Product Change Notification: PCN-23-168223

HDR ASSY, VERT., SURFACE MOUNT, SM AND THRU-HOLE HOLDDOWN, TIN AND GOLD, DUAL ROW, MICRO MATE-N-LOK.

Description of Changes

We are doing improvements in the customer drawings in order to make them standardized, clearer and with more and better information. (Marked Copies available)

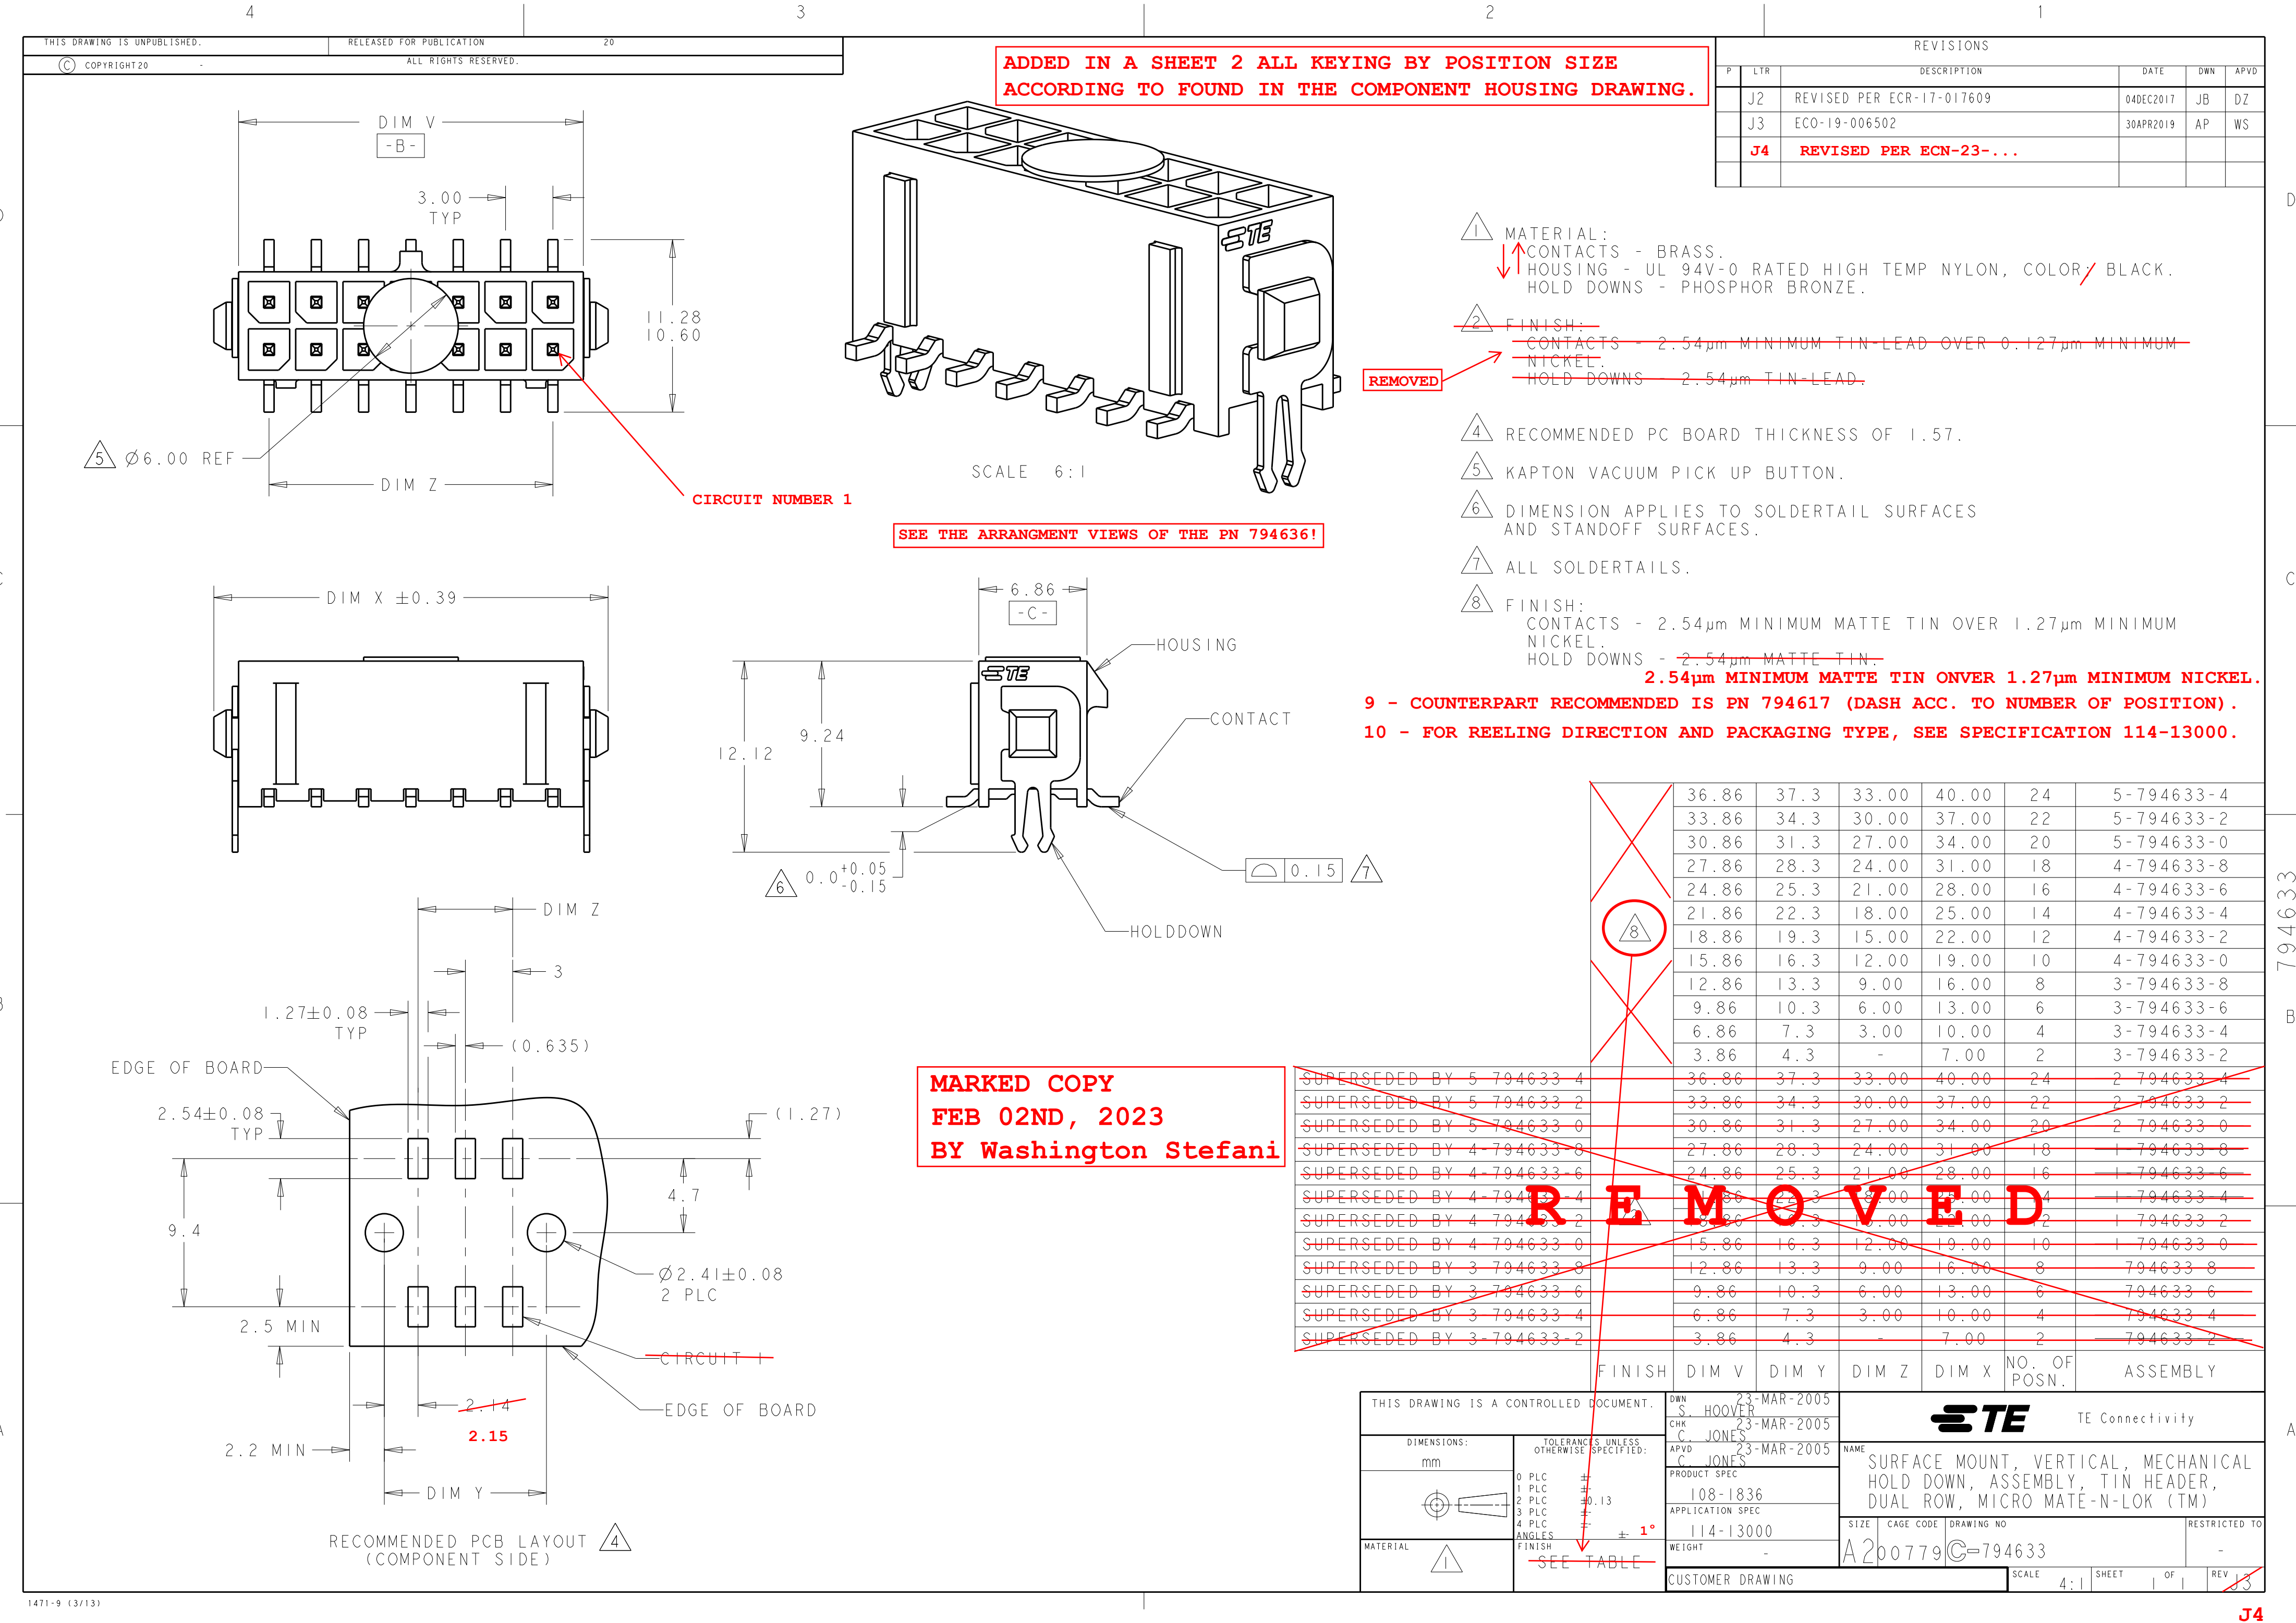
ADDED IN A SHEET 2 ALL KEYING BY POSITION SIZE
ACCORDING TO FOUND IN THE COMPONENT HOUSING DRAWING.

REMOVED
